RAI Volume 2, Chapter 2.1.1.5, Second Set, Number 1

Figure 1. Buffer Area Dose Rate (mrem/hr) Contour Map in Log Scale

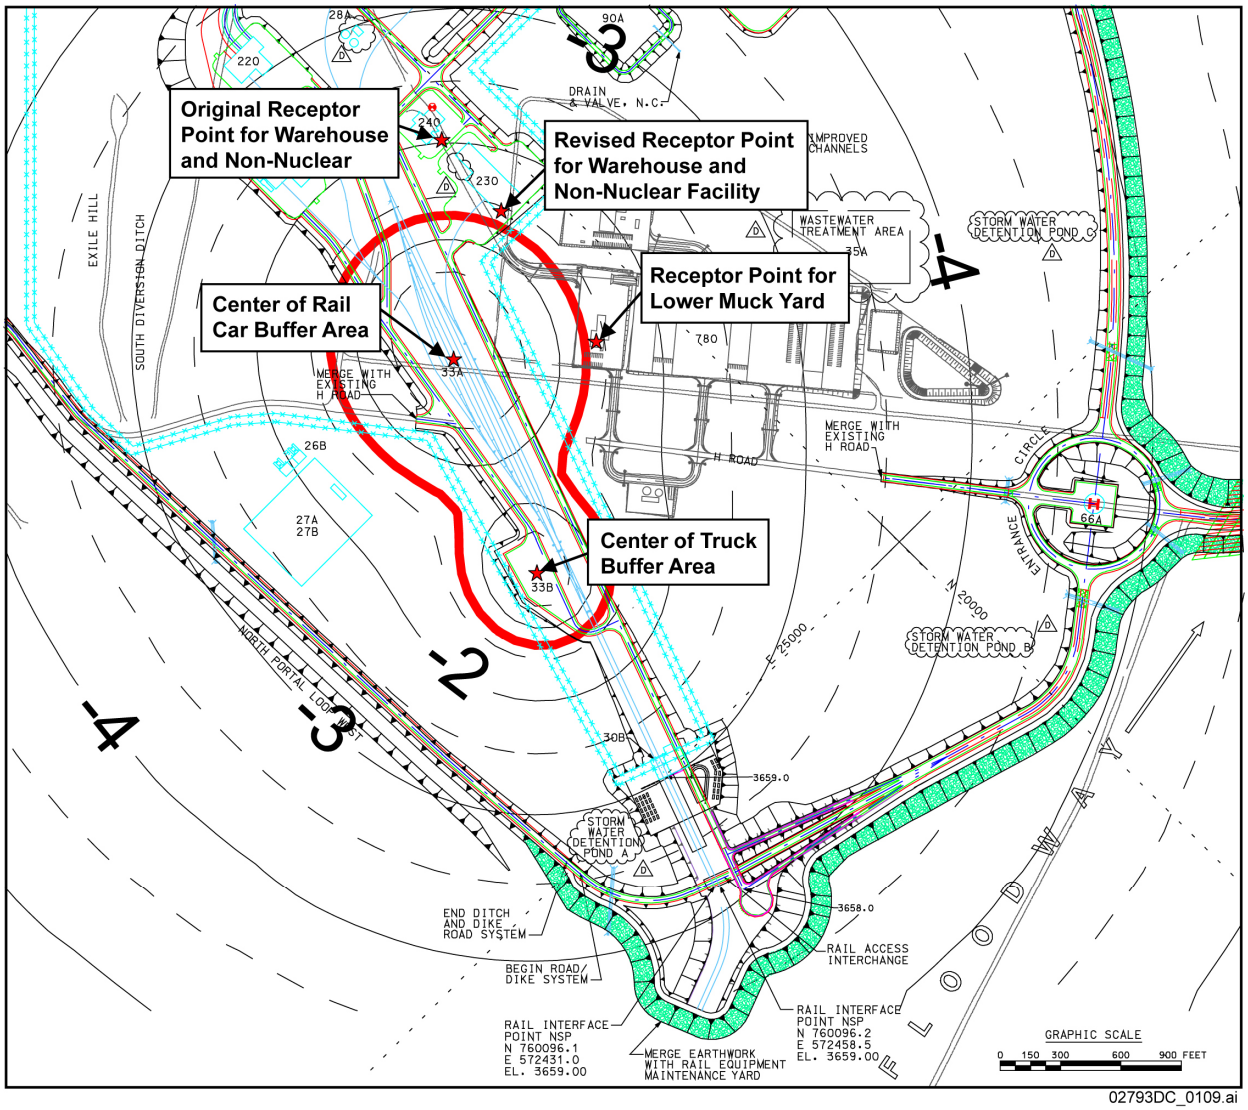
Provide the technical basis for the potential onsite public doses during normal operations, listed in SAR Table 1.8-28. Specifically, address the following:

a. Explain the basis for the public dose at the Warehouse and Non-Nuclear Facility location (17 mrem/yr) being significantly smaller than the dose at the Lower Muck Yard location (78 mrem/yr), even though the Warehouse location is at a similar distance from the Rail Car and Truck Buffer areas.

e. Explain how the values in BSC (2007am, Table 7) were developed, including how the values in Column III represent the dose rate for 25 casks, and basis for not accounting for truck cask numbers (5) in column V. Also, provide a reference or describe the location and boundaries for the buffer areas.

The public dose reported for the Warehouse and Non-Nuclear Facility (Area 230) listed in SAR Table 1.8-28 was inadvertently calculated at a dose receptor location outside of the facility. Revised coordinates have been developed to locate the dose receptor within the Warehouse and Non-Nuclear Facility at the shortest distance to the buffer areas. Figure 1 presents the locations of the original and revised receptor points for the Warehouse and Non-Nuclear Facility.

Figure 1 also provides a dose rate contour map surrounding the buffer areas and locations of the centers of the railcar and truck buffer areas. The dose rate contour lines are lines of constant dose rate (mrem/hr) based on a logarithmic scale (e.g., 10^{-2}, 10^{-3}). Using the contour map in Figure 1, the revised estimated annual onsite public dose for the Warehouse and Non-Nuclear Facility is

76 mrem. This value is estimated by interpolating between the dose rate contour lines surrounding the revised receptor point for the Warehouse and Non-Nuclear Facility. The onsite public doses are based upon an exposure time of 2,000 hours per year.

The locations of the buffer areas in the GROA are identified in SAR Figure 1.2.1-2. The centers of the buffer areas used to distribute the transportation casks are indicated in Figure 1.
